FOI reference: TCCSFOI 20-074

BLOCK 15 SECTION 40 MACGREGOR

PRELIMINARY DESIGN STAGE ROAD SAFETY AUDIT

PROPOSED SECOND DRIVEWAY FOR "MR FLUFFY" DUAL OCCUPANCY

SITE /LANDSCAPE MANAGEMENT AND PROTECTION PLAN

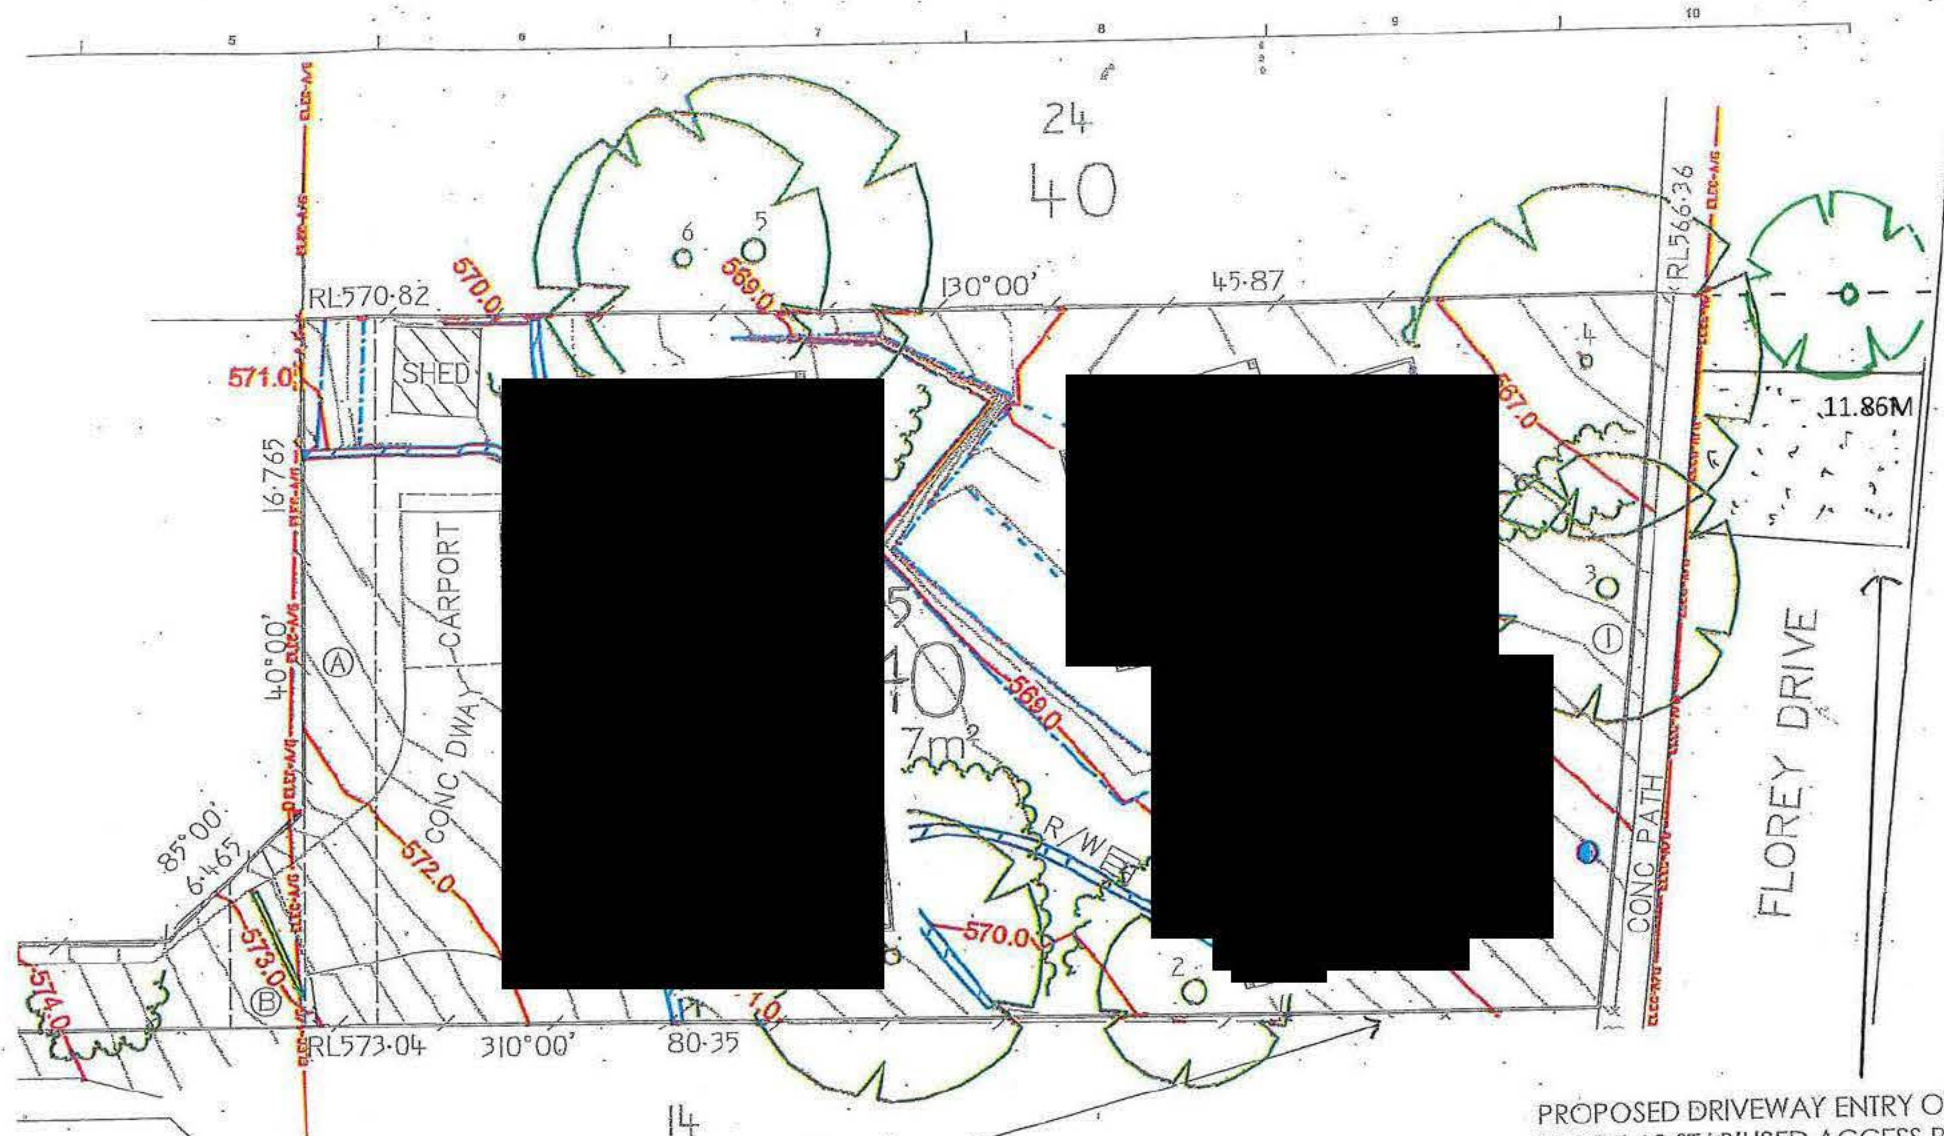
We DRC has no objection for the proposed second driveway. However, there is an unleased land between your block and the road verge (Please see attached plan). So you need to contact EPSDD for the legal implication before the TCCS endorsement.

As we discussed on the phone, DRC has no objection for this proposed second verge crossing and the location. We will check all of the clearance requirement once we received application for the formal approval. I have already advised the applicant to contact EPSDD for the legal implication before the TCCS endorsement.

Further to the above, I observed a number of issues with the site plan provided and offer the following preliminary advice based on the information available:

- The proposed dwelling fronting Florey Drive appears to encroach into the front 6m setback from this frontage (please note I am unable to determine the extent of the encroachment as the plans are not to scale or dimensioned). You will need to identify the extent of the encroachment and provide a detailed response to the relevant criteria to support the siting of the dwelling. Consideration of this encroachment is subject to the application being assessed;

- Driveway long section may be required depending on levels proposed;

SITE /LANDSCAPE MANAGEMENT AND PROTECTION PLAN

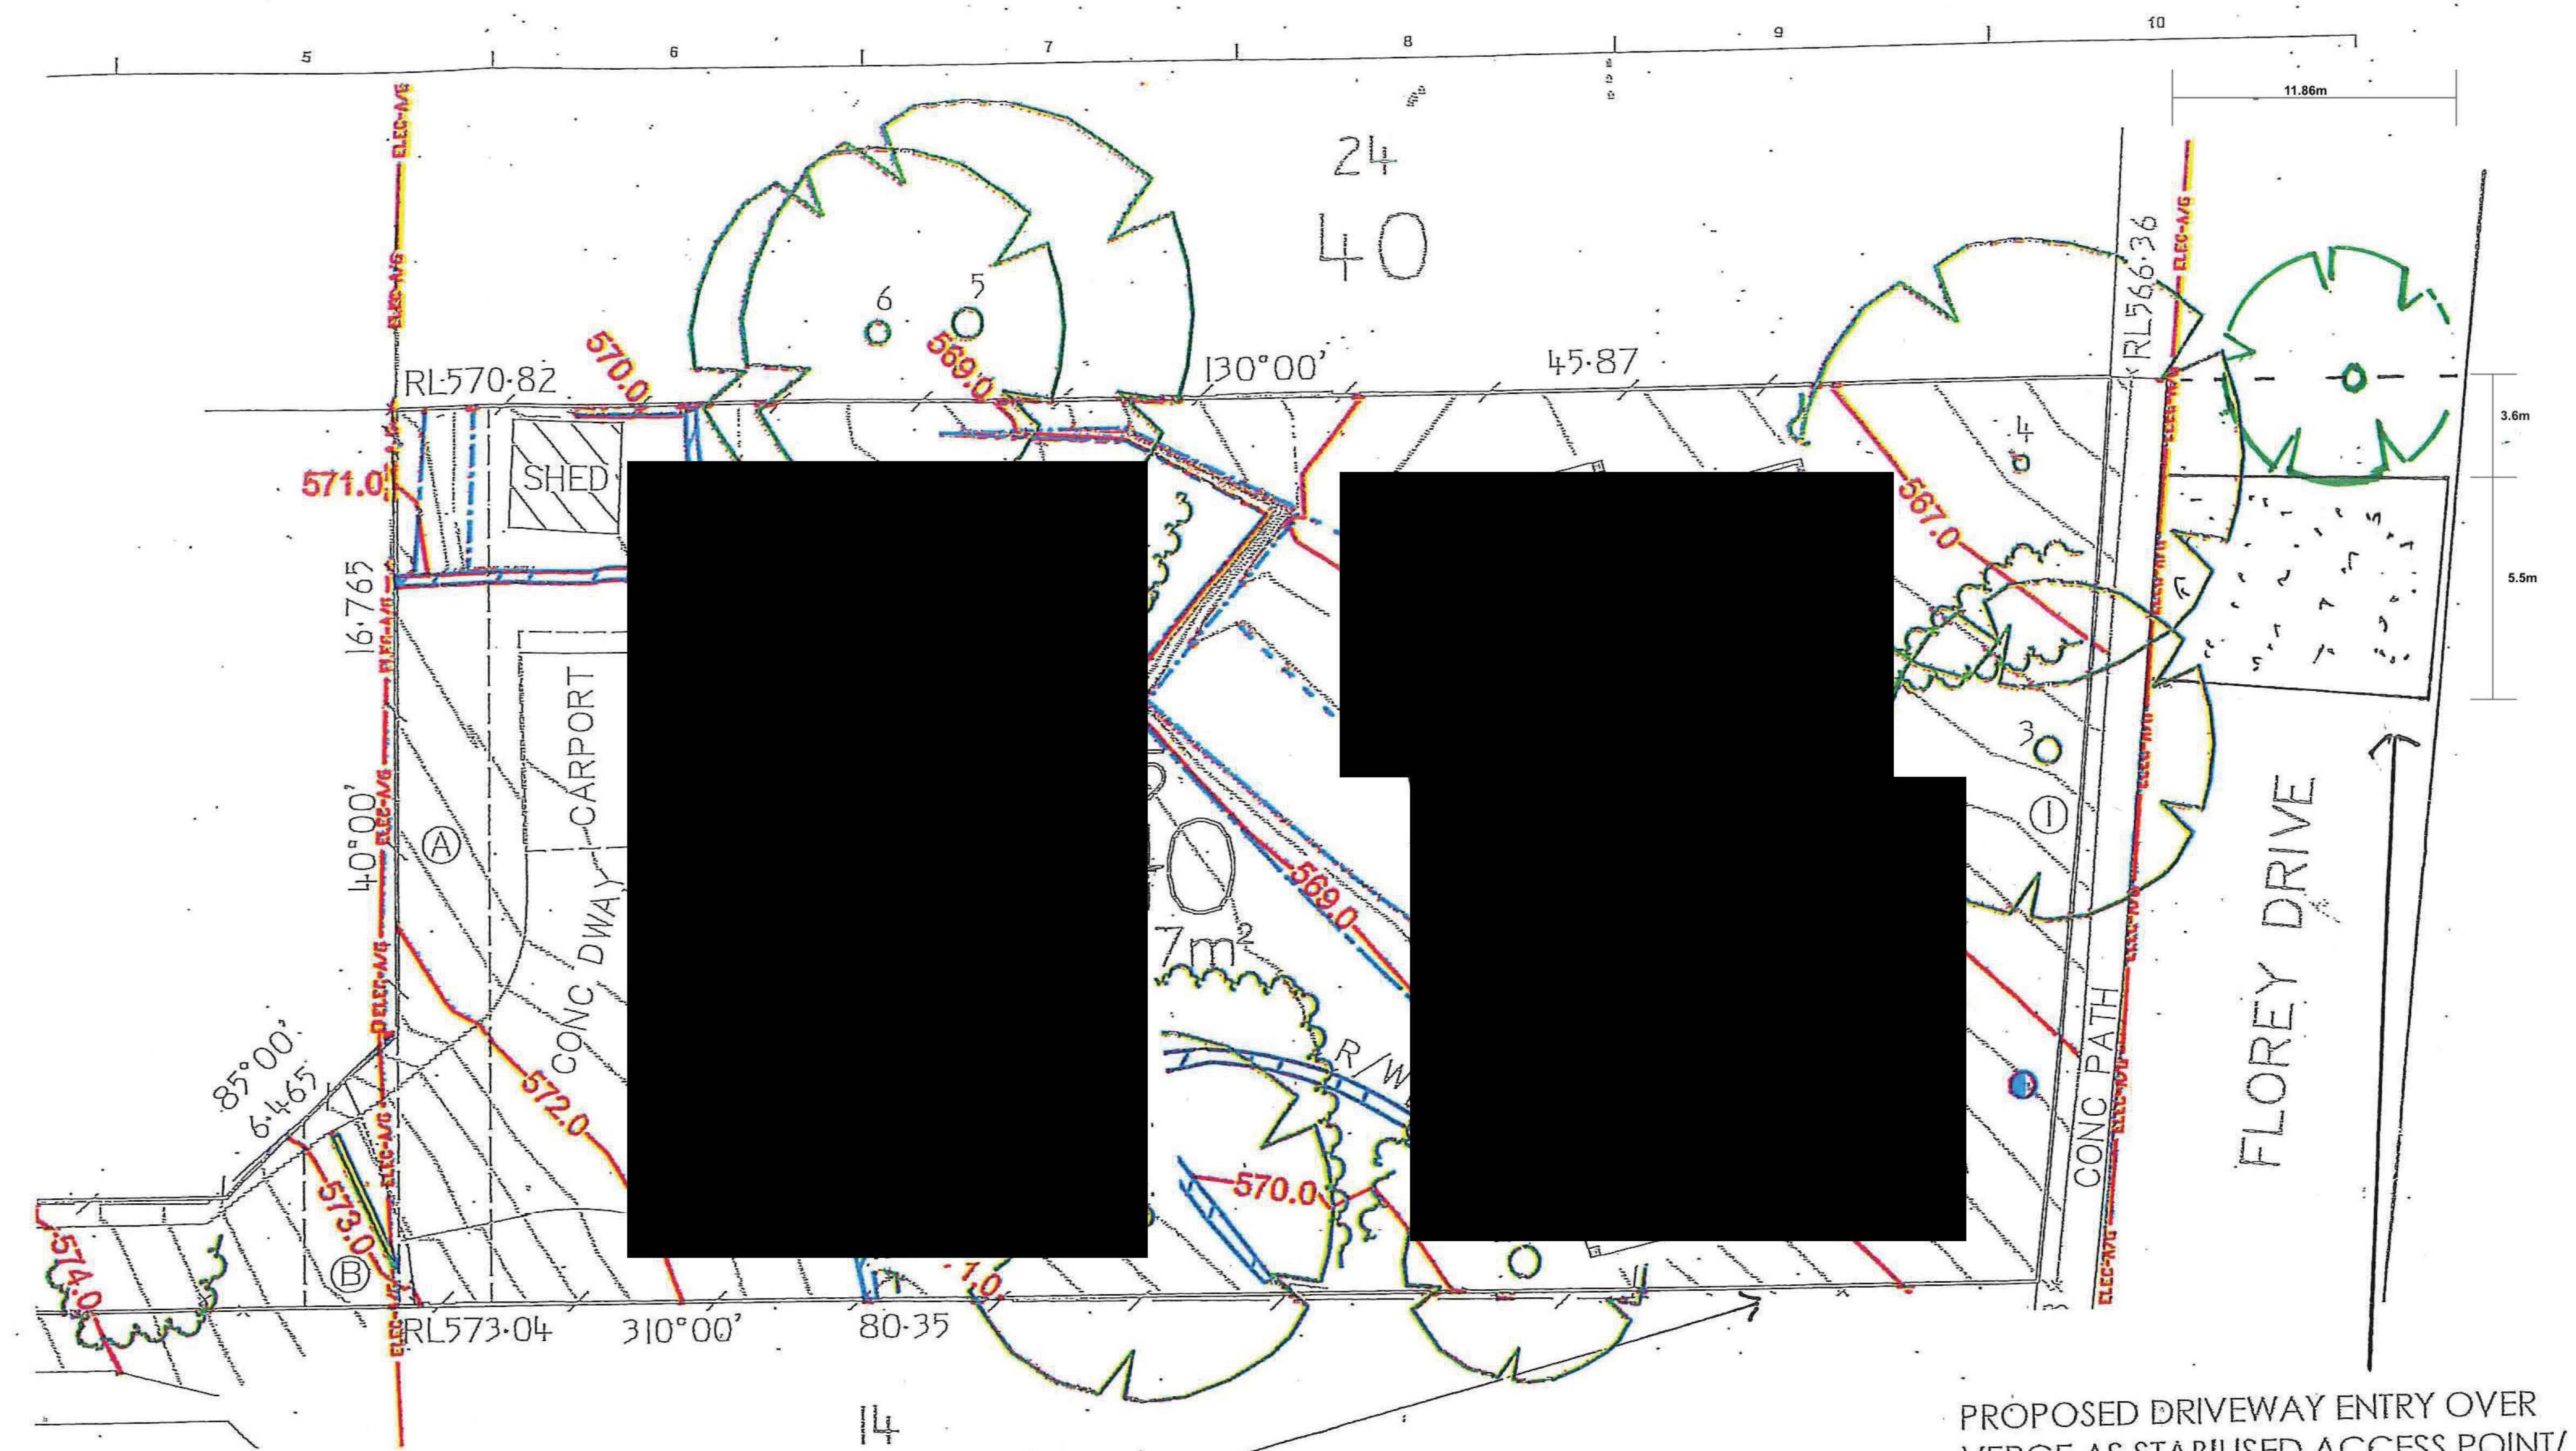
DRC understands the narrow block of land between the block boundary and the road verge was created primarily to prevent direct access to the blocks from Florey Drive. Our previous advice to you regarding the feasibility of a second driveway was based on engineering assessment only, pending clarification of the existing planning requirements of the land surrounding the block.

DRC has assessed the concerns raised in your email in consultation with ESPDD and could not find any reasons to support a second driveway from Florey Drive. Hence there is no change in the DRC's decision conveyed to you by email dated 7 March 2018. Your combined application (Reference Code LMDXH2) for Stormwater Clearance and second driveway has not been endorsed. However, the proposed building layout has no impact on the existing stormwater easement and the plan for same is endorsed and returned as attachment to this email. The balance amount due as a result of this adjustment will be refunded as early as possible.

*Please note while the current provisions of the Territory Plan stipulate additional driveway verge crossings **may** be allowed, a second access point is not an entitlement and is required to be endorsed/approved. In this instance it is not considered appropriate to depart from our established position.*

I am pleased to inform you that your request for a second driveway from Florey Drive as shown in the attached plan is approved with condition for formwork inspection before concreting. You may contact the Driveway Section of this office (Stan or Asm on 6205 8084 or 6207 6749) for formwork inspection a few days before concrete works. Further no fees will be charged for this formwork inspection.
